**NOTICE OF A REGULAR MEETING OF THE DESIGN REVIEW BOARD
OF THE TOWN OF CLARKDALE
WEDNESDAY, SEPTEMBER 7, 2022 AT 6:30 PM**

A. NEW SIGN AND EXTERIOR PAINT AT 414 PEACE GARDEN PATH, CLARKDALE, AZ

Public Hearing for application DRB-093564, submitted by Novie Trump and Eric Flippo for proposed signage and new exterior paint colors at 414 Peace Garden Path, Clarkdale, AZ. (APN 400-07-026F)

Staff Report

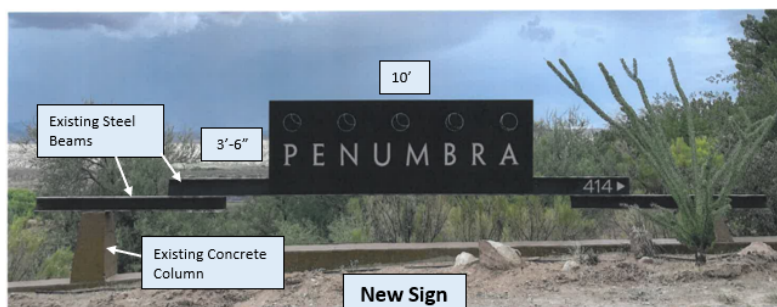
2. Minimum setback from the property line equals one foot for each foot of height of the sign for signs six feet or less in height; for signs more than six feet in height the setback shall be greater than or equal to the height of the sign. The existing sign base meets setbacks of previously approved signage (Sedona Wellness).

3. Low-water use, drought-tolerant plants from the Town of Clarkdale Plant List, Section 9-090 of the Zoning Code, or landscape rocks may be placed around the sign base to minimize the visual impact of a monument sign and create a visually attractive appearance. Existing, low-water landscaping at the base of the sign.

4. One monument sign is allowed for each road intersection providing access to the property. One monument sign is proposed.
5. See Section 7-090 of this Code for maximum signage square footage. 40-foot street frontage x 1.5 square feet per each foot of frontage = 60 square feet allowed. 35 square feet is being proposed.

6. Base of sign must be in proportion to sign size area. The steel I-beam sign base is proportional to the size of the sign.
7. Maximum height of the sign and base shall not exceed 10 feet above existing grade at the time of construction. The sign height will be six feet above existing grade.

The proposed sign will be constructed of 3/8-inch steel plate and welded to an existing structure of steel I-beams supported by concrete columns, facing Broadway at the entrance to the applicant's property. Attached to the sign will be 10 inch high steel letters spelling PENUMBRA. Five circular shapes will be cut through the steel plate to represent the moon phases. To the right of the sign, 6 inch high address numbers will be attached to the existing steel beam with a directional arrow.
